RE: Smith Ranch – Highland Uranium Project
Docket No. 40-8964, SUA-1548
A-Wellfield Ground Water Restoration Information

Ground Water Restoration Report, A-Wellfield, Highland Uranium Project

**RE: TFN 3 4/261, Review of the A-Wellfield Groundwater Restoration Report,
Power Resources Inc., Permit No. 603**

Figure 1., Contoured A-Wellfield Water Level Elevations, 01/27/2000

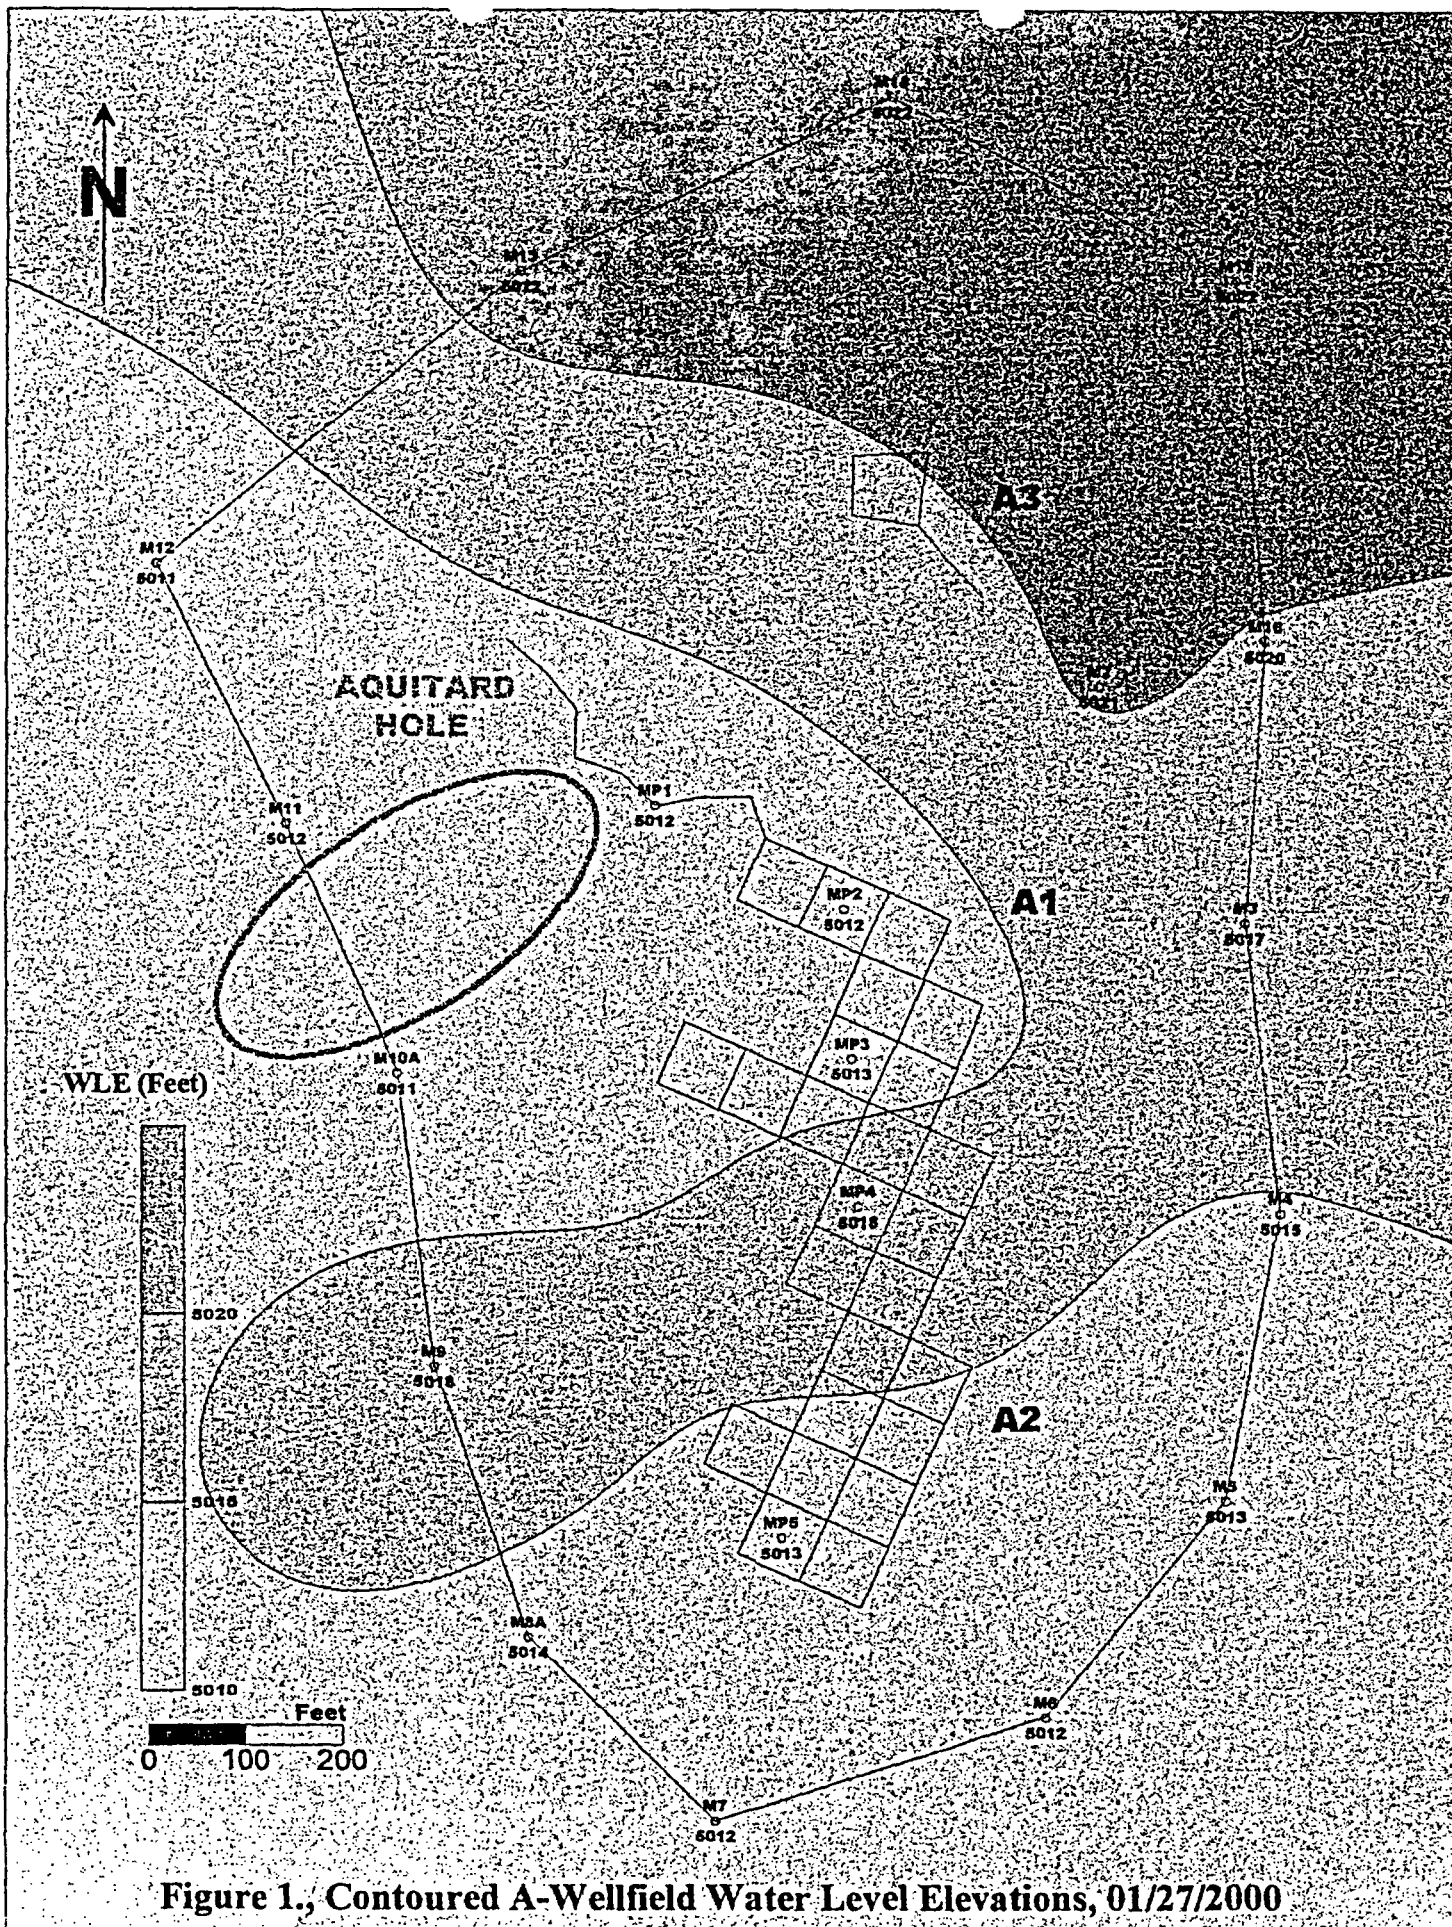
Please provide an end of stability potentiometric surface map and at least six months of water level data, when obtained, to determine if the ground water flow pattern is stable.

A potentiometric surface map, which was developed from water level data collected at the end of stability, is provided as Figure 1 in the A-Wellfield Ground Water Quality Stabilization Report. As discussed in Section 2.2.1, Potentiometric Surface Map, this map shows that the ground water flow pattern is stable. Water level data are included for all of 1999 in Appendix 5.2.
